HCOM-SB-47

**GENERAL
SERVICE BULLETIN**

SUBJECT: 8-CYLINDER MODEL E OPEN AND HERMETIC COMPRESSOR, MINIMUM UNLOADING CHANGE

FIGURE 1

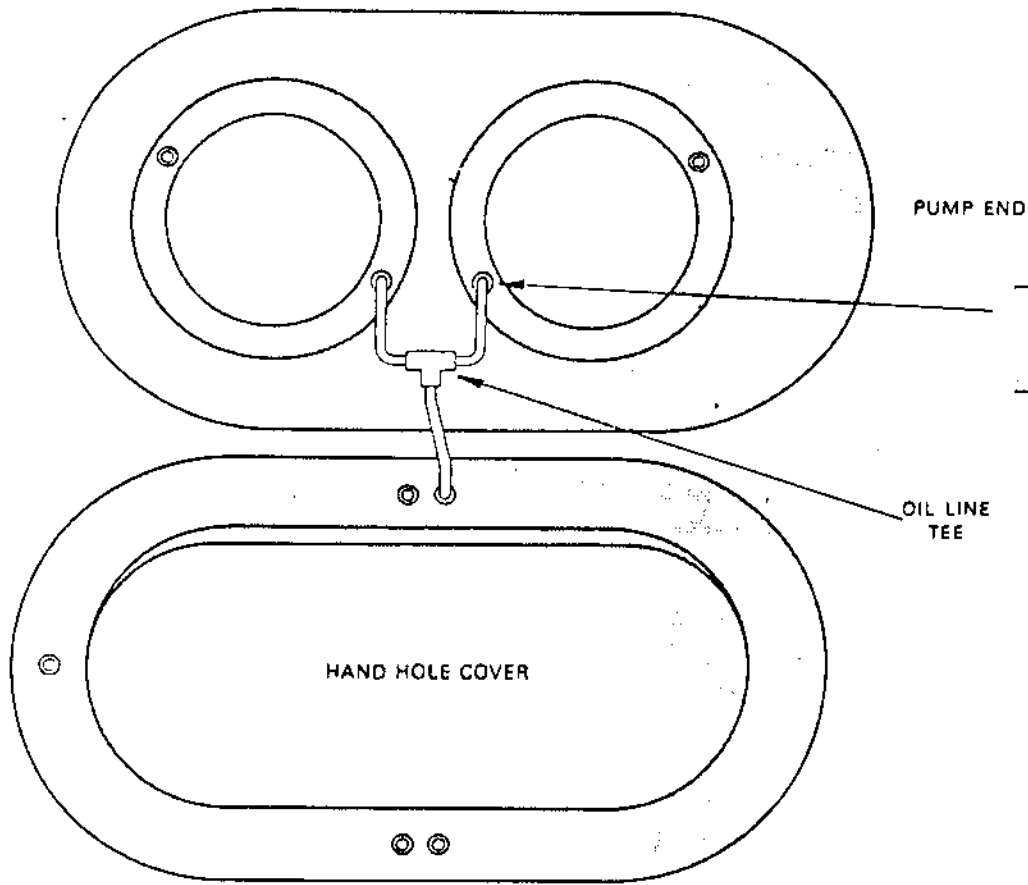
1. With compressors that are to be completely rebuilt, it is recommended that the oil supply line to cylinder number 7 be capped off and soldered shut (See Figure 1). A cylinder liner assembly (without unloaders) should be installed. NOTE: Do not pinch or crimp oil supply line. Vibration will eventually break the line.
2. The oil supply line, on units in operation, can be plugged by removing the oil connector (CON-1) and "O" rings and soldering the hold shut. (See Figure 2). To assure an oil tight seal, new "O" rings (RNG-10) should be installed.

FIGURE 3

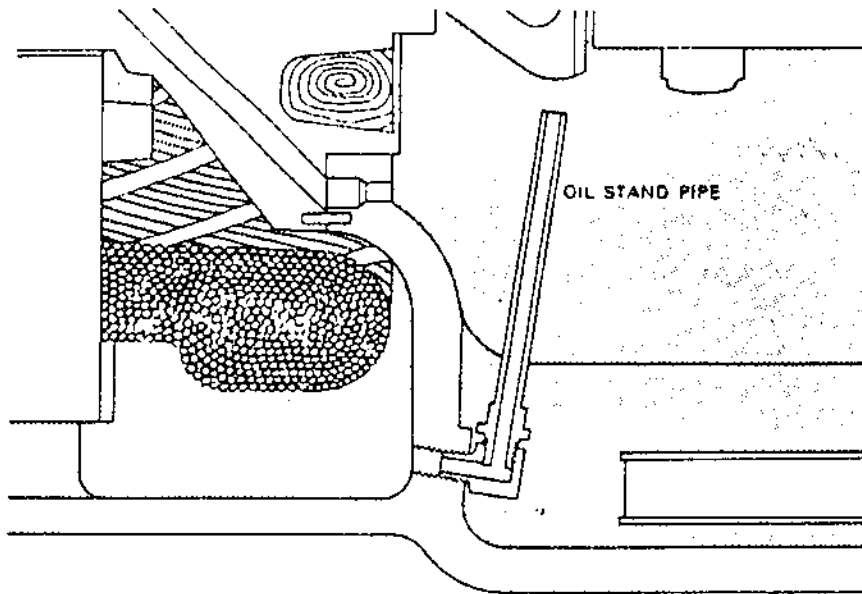
The number of unloading cylinders on the 8-cylinder Model E was reduced from six to five cylinders. This maintains an operating minimum of three cylinders instead of the previous two. The oil return check valve (between the compressor suction cavity and crankcase) was replaced by an oil stand pipe. The upper housing oil drain check valves were replaced by oil return drain orifices.

Figure 3 illustrates the oil stand pipe for Model E Hermetic only. The open version has a $\frac{1}{2}$ " coupling and elbow located closer to the crankshaft.
